USB Power Delivery ENGINEERING CHANGE NOTICE

Title: Cable Reset Issues

Applied to: USB Power Delivery Specification Revision 3.0 Version 2.0

Figure 8-140 Cable Plug Soft Reset State Diagram

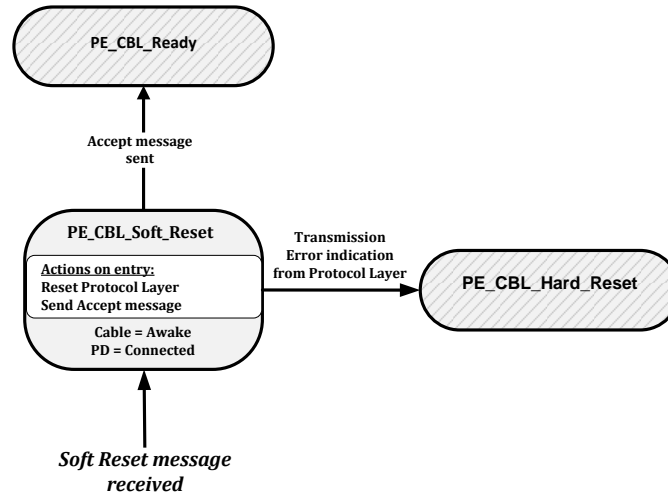
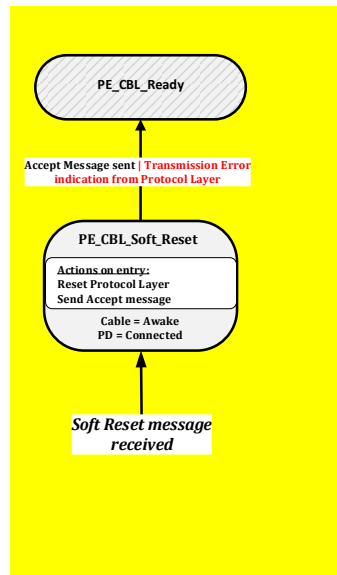
- If a Cable Plug receives a Soft_Reset Message and there is a Transmission Error, it continues into executing a Cable Reset which exits all Active Modes which the Cable Plug should never do on its own and without the VCONN source knowing it exited all modes
- When a UFP (VCONN Source) executes a Soft Reset to the Cable Plug and that communication fails (SenderResponseTimer timeout for example), it proceeds to a Cable Reset which only a DFP can do

(a). Figure 8-140 and Section 8.3.3.24.2.1.1

The Policy Engine **shall** transition to the **PE_CBL_Ready** state when:

- The **Accept** Message has been sent
- The Protocol Layer indicates that a transmission error has occurred.

Figure 8-142a DFP and VCONN Source Soft Reset or Cable Reset of a Cable Plug or VPD State Diagram

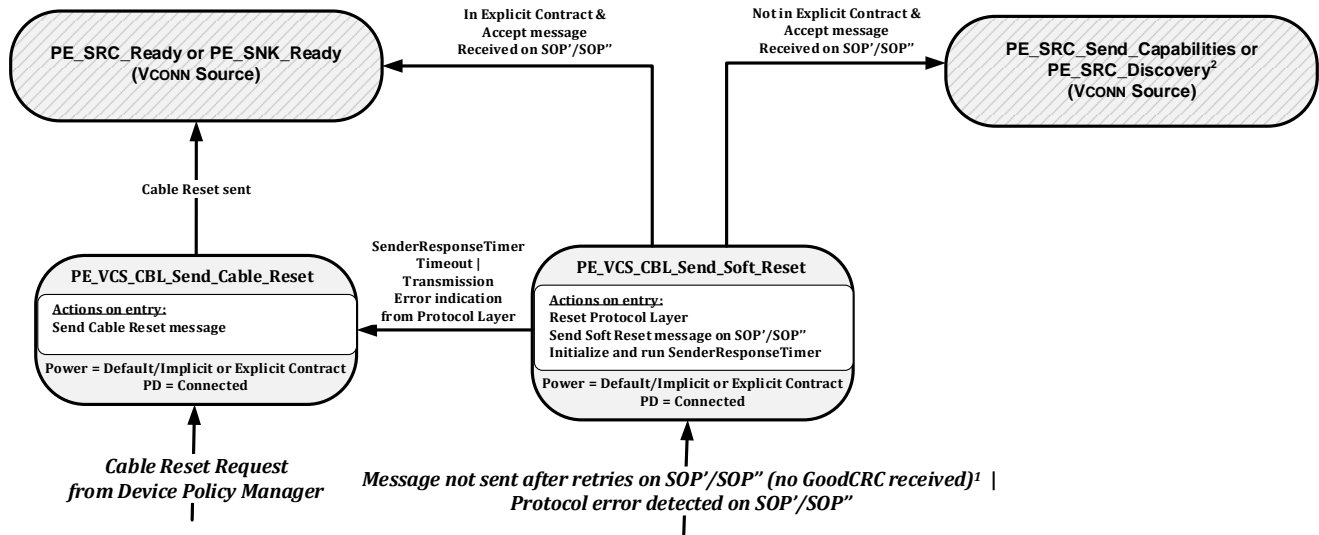
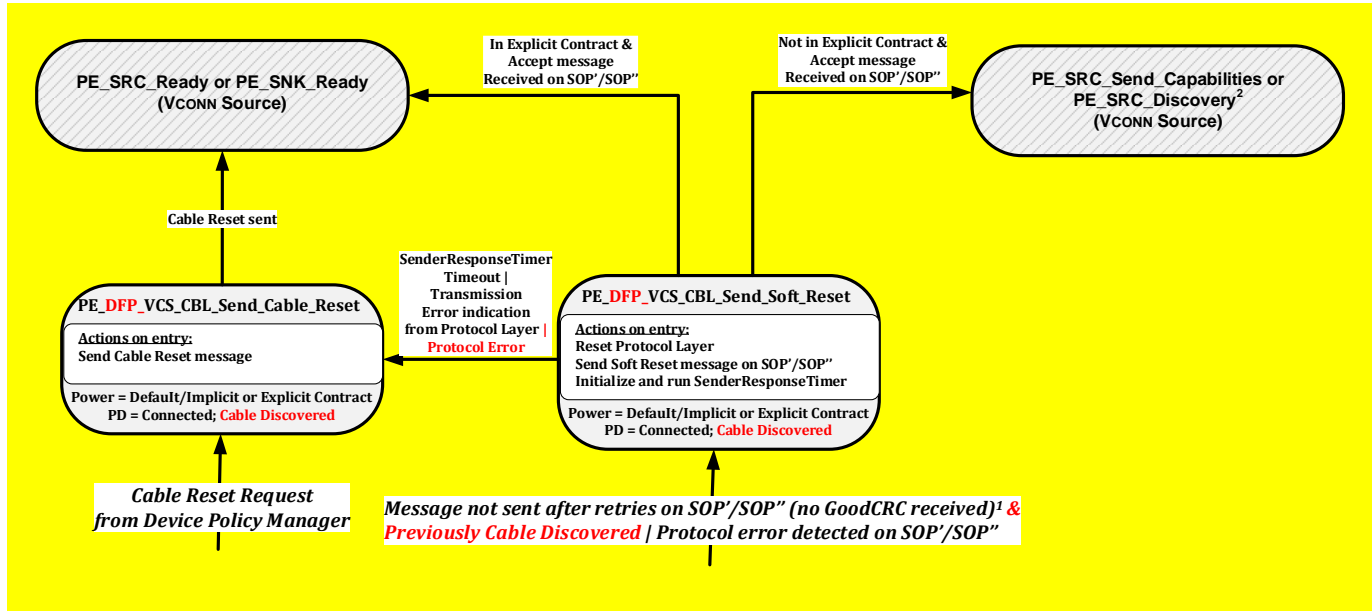
(b). Sections 8.3.3.24.2.3

The *PE_DFP_VCS_CBL_Send_Soft_Reset* state *Shall* be entered from any state when a Protocol Error is detected on *SOP'/SOP''* by the Protocol Layer (see Section 6.8.1) or when a Message has not been sent after retries on *SOP'/SOP''* while communicating with a Cable Plug/VPD **and when there was previous communication with the cable plug that did not result in a Transmission Error** or whenever the Device Policy Manager directs a Soft Reset on *SOP'/SOP''*.

The Policy Engine **Shall** transition to the **PE_DFP_VCS_CBL_Send_Cable_Reset** state when:

- A **SenderResponseTimer** timeout occurs
- Or the Protocol Layer indicates that a transmission error has occurred
- Or when a Protocol Error is detected on **SOP'/SOP''** by the Protocol Layer
